COOLING STATIONS

Page 59 , Volume 1 Draft PEIS Ny Bight
regarding cooling systems.

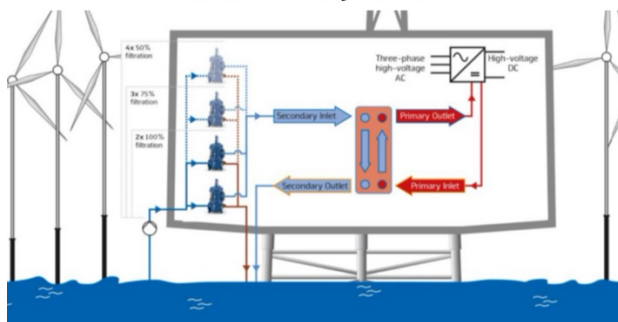
2. Thermal Pollution: Open loop cooling systems release heated water (86-90F) back into the ocean after it has been used to dissipate heat from the conversion of AC to DC electricity. This can result in localized thermal pollution, where the discharged water is warmer than the surrounding environment. Elevated water temperatures can stress marine organisms, disrupt habitat suitability, and alter ecological processes.
